## Summary of Items Discussed in 1/2022 APSEC Discussion Forum on 14 January 2022

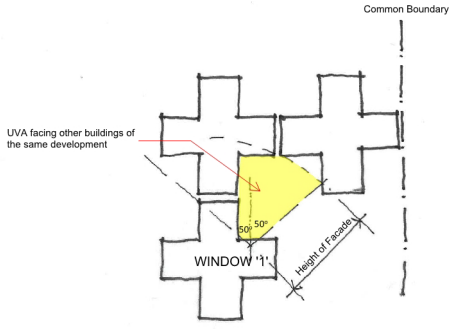
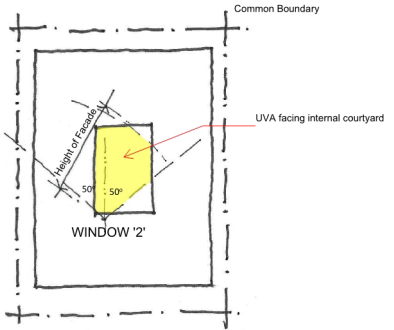
Items proposed by Convenors for Discussion	Summary of Discussion and BD's Response
	<b>Items raised by HKIA</b>	
1.	<p><b><u>Application of UVA Method for Provision of Natural Lighting and Ventilation within a Courtyard of a Building</u></b></p> <p>Under PNAP APP-130, the unobstructed vision area (UVA) method is acceptable as an alternative way to demonstrate compliance of natural lighting and ventilation requirements. Please advise whether such UVA method is applicable to windows opened onto unobstructed area facing buildings and site boundary, as well as within a 4-side enclosed (but vertically unobstructed) courtyard within a building or between buildings (see Scenario 1 and 2 below).</p> <div style="display: flex; justify-content: space-around; align-items: flex-end;"> <div style="text-align: center;">  <p>Scenario 1: UVA facing other buildings of the same development</p> </div> <div style="text-align: center;">  <p>Scenario 2: UVA facing internal courtyard</p> </div> </div>	<p>BD accepted the unobstructed vision area (UVA) method to demonstrate compliance with the performance requirements. The principles and requirements of the UVA method were described in paragraphs 3.3 and 3.4 of Appendix A to PNAP APP-130. For scenarios not meeting the requirements, APs might alternatively demonstrate compliance with the above performance standards using any suitably verified and scientifically validated methods.</p> <p>According to paragraph 3.4 of Appendix A to PNAP APP-130, no window in the building should be counted for the calculation of UVA unless it faced into a space which was uncovered and not bounded on the side opposite the window by any obstruction of the building.</p> <p>Based on the above, BD advised that the UVA method was applicable to Scenario 1, but generally not applicable to Scenario 2. Subject to individual case merit, APs might discuss with the case officers including CBS for the particular issue.</p> <p>In response to HKIA's request, BD would consider reviewing the</p>

application of the UVA method as an alternative way to demonstrate compliance with natural lighting and ventilation requirements.
2.	<p><b><u>Covered Areas under Elevated Structures and Large Projecting/Overhanging Features – JPN No. 4 and PNAP APP-19</u></b></p> <p>Under Group I in the Appendix to JPN No. 4:</p> <p>Item 1: elevated structures are not accountable for gross floor area (GFA), provided BA is satisfied that the covered areas underneath such elevated structures would not be abused; and</p> <p>Item 12: covered areas under large projecting / overhanging features are not accountable for GFA provided they fulfill the requirements in paragraph 6 of PNAP APP-19.</p> <p>(i) Please clarify whether covered areas under <b>elevated footbridges</b> between two buildings within the same site are GFA accountable, if the concerned covered areas will not be abused, due to the fact that they are used as:</p> <ul style="list-style-type: none"> <li>- EVA with footpath;</li> <li>- Driveway for vehicles; and/or</li> <li>- Planters, etc.</li> </ul> <p>(ii) Please clarify if items 1 and 12 apply to <b>building setback area</b> covered by the upper part of the building which fulfills the</p>	<p>BD advised that, in general, the covered areas under the elevated footbridge between two buildings were GFA accountable under regulation 23(3)(a) of B(P)R. If the covered areas were used as EVA with footpath / driveway / planters of genuine design, or were designated as common parts of the building satisfying the requirements in paragraph 6 of PNAP APP-19, BD would pragmatically consider excluding such covered areas from GFA calculation under regulation 23(3)(b) of B(P)R on its case merits, provided that the covered areas were open in design and abuse was unlikely. Similar item was also mentioned in item 5 of ADF 5/2021 held on 12 November 2021.</p> <p>Elevated structures under Item 1 of Group I in the Appendix to JPN No. 4 referred to elevated platforms over sloping site, e.g. elevated garden areas and terraces, which were irrelevant to building setback area.</p> <p>For covered areas under projecting / overhanging features under Item 12 of Group I, if the projecting / overhanging features satisfied the requirements in paragraph 6 of PNAP APP-19, BD would pragmatically consider excluding the covered areas from GFA calculation on its case</p>

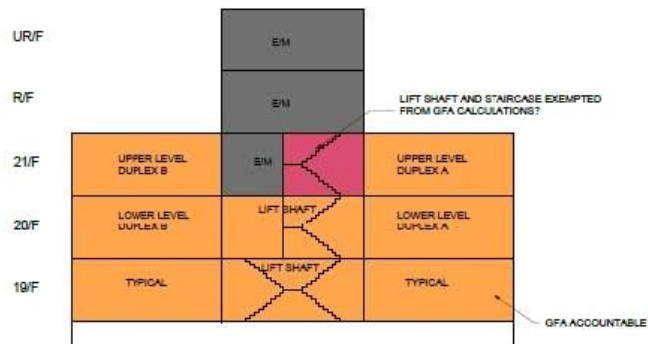
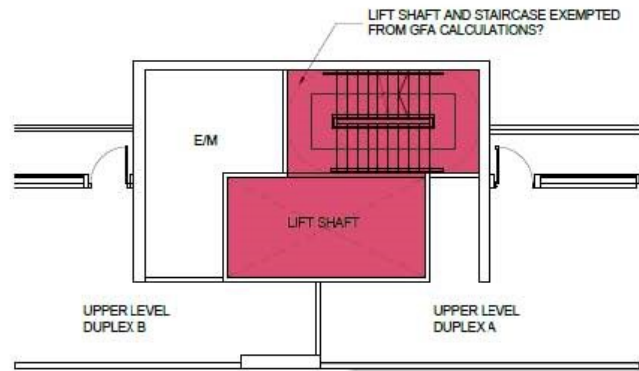
<p>5.</p>	<p><b><u>Rooftop Staircase Hoods of Residential Developments – JPN No. 4</u></b></p> <p>Regarding item 20 of ADF 5/2019 held on 22 November 2019, BD replied that whether GFA would be accountable for the staircase hood on roof of a private staircase linking the top floor to the roof would be considered on a case-by-case basis.</p> <p>Subsequent to the above discussion, the recent revision of JPN No. 4 stipulates that rooftop staircase hoods of residential developments are not</p>	<p>BD advised that the staircase hood of a private staircase linking the top floor to the roof might be non-accountable for GFA calculation provided that the size of the staircase hood was not excessive and that no other building facilities, features and structures at roof were accountable for GFA.</p> <p>There had not been any change in BD's requirement. The revised JPN</p>

<p>counted towards GFA calculation provided that the size of the staircase hood is not excessive and that no other building facilities, features and structures at roof are accountable for GFA.</p> <p>In light of the above, can BD please clarify that provided the criteria in JPN No. 4 are met, the staircase hoods of private staircases on roof level in residential developments would not be GFA accountable, despite the fact that the first GBP is submitted before the effective date of the current revision of JPN No. 4.</p>	<p>No. 4 was issued to align the practices in determining the GFA accountability amongst BD, LandsD, and PlanD.</p>
<p><b>Items raised by HKIE</b></p>		
<p>6.</p>	<p><b><u>Acceptance of Hoarding Plan Prior to Approval of Demolition Plan</u></b></p> <p>Recently, it is noticed that a demolition plan was not approved by BD because the hoarding plan had not yet been accepted. Would BD please clarify whether the acceptance of hoarding proposal is a pre-requisite for demolition plan approval?</p>	<p>BD advised that according to paragraph 1(a) of Appendix D to PNAP ADM-19, precautionary measures particularly the hoarding, covered walkways and any necessary propping and shoring were the fundamental issues to be considered in processing demolition plans. While acceptance of hoarding proposal was not a pre-requisite for approval of demolition plans under the Buildings Ordinance, adequate precautionary and protective measures for the demolition works should be included in the demolition plans submitted for approval. Regulation 8(3) of Building (Administration) Regulations, Section 3 of the Code of Practice for Demolition of Buildings 2004 and PNAP APP-21 referred.</p>
